## Service Bulletin

**E132**

New Composite Oil Pan and Drain Plug in PACCAR MX-11 and MX-13 Engines

11/5/2015

Quantity	Part #	Description
1	1982821PE	Oil Pan Drain Plug w Oring

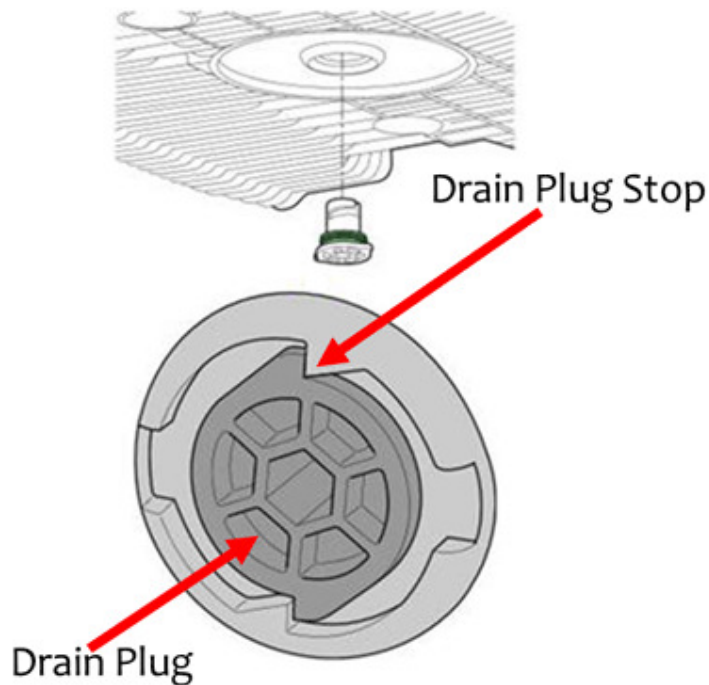
All PACCAR MX-11 and MX-13 engines now have composite oil pan and drain plug. See procedure below.

**PLEASE NOTE: Do not over-torque the drain plug.**

- Use the correct tool (8 mm allen (hex head) wrench) to remove or install the drain plug.
- If the maximum torque is reached, the hexagonal tool will slip through the plug.
- After draining the oil, always replace the drain plug assembly (o-ring included) with a new one.
- Torque the drain plug to its stop, do not over torque.
